TECHNICAL BULLETIN

Poor Running in Wet or Hot Weather Conditions – Replace Air Cleaner Housing

19-31

MODEL Sedan (3.6/4.0L) Range through 94 MYDATE 2/95
Up to VIN 708757

ILLUSTRATION 1

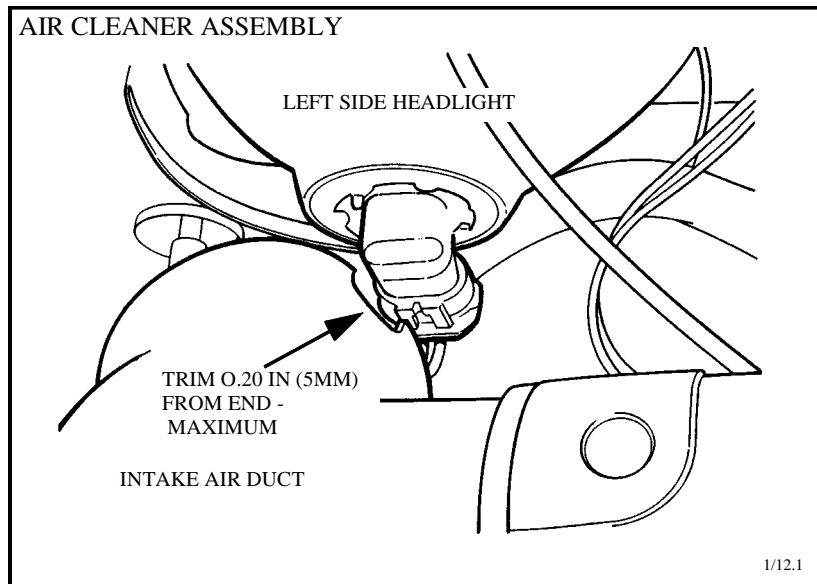
5. Route the wiring harness behind the left headlight to ensure clearance for the new air intake duct.
6. Trim the flared end of the air intake duct with a round file to provide clearance for the left headlight assembly as shown in Illustration 1.

IMPORTANT: Do not trim more than 0.20 in (5mm) from the end of the air intake tube.
Profile the trimmed area to provide clearance for the headlight connector assembly.
Radius all sharp edges of the trimmed area to avoid intake air “whistles” or noise.
